PROJECT TITLE:
HUNTER'S LODGE
Proposed Ancillary Outbuilding/Garage

DRAWING TITLE:
SECTIONS

SHEET NO.
HL/GR/05/D

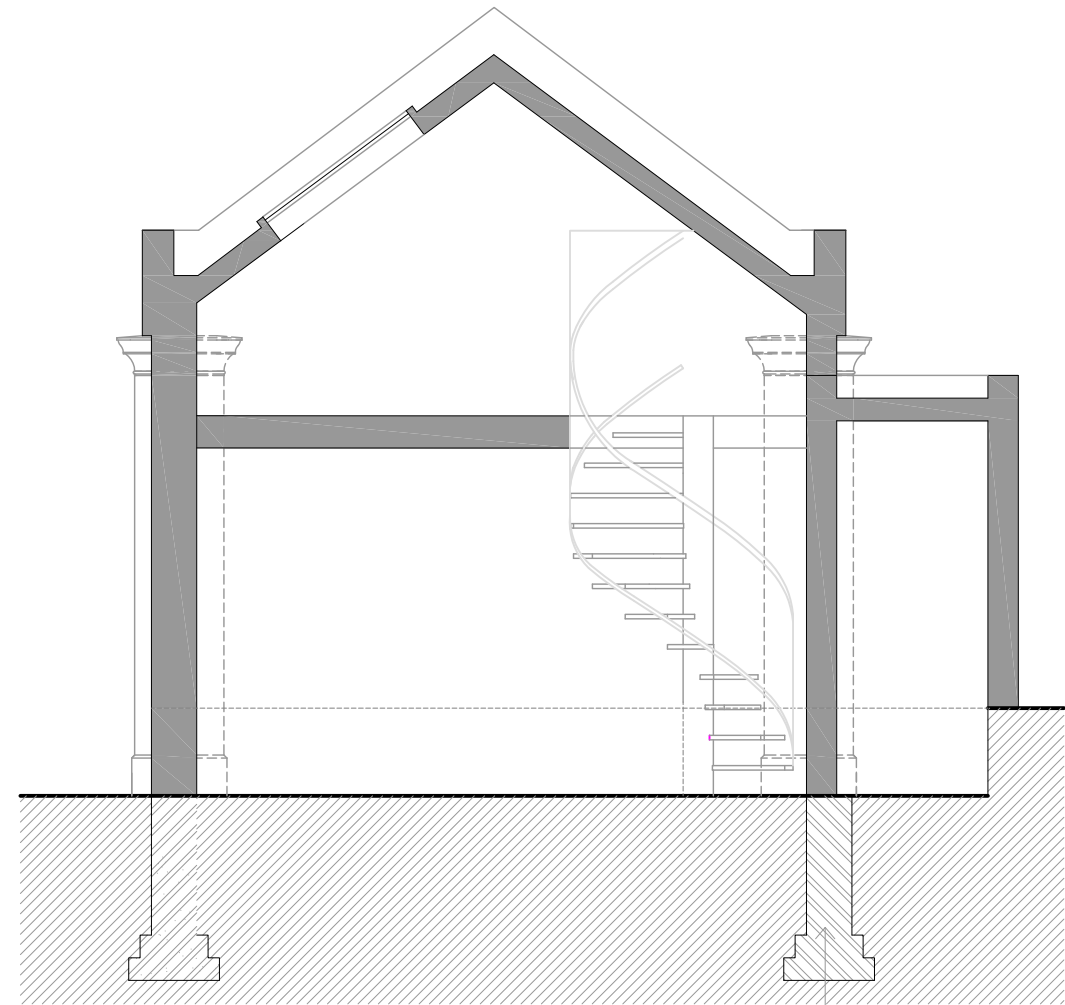
Foundations to be 1.8m deep as requested by Building Inspector (due to proximity of trees and ground conditions)
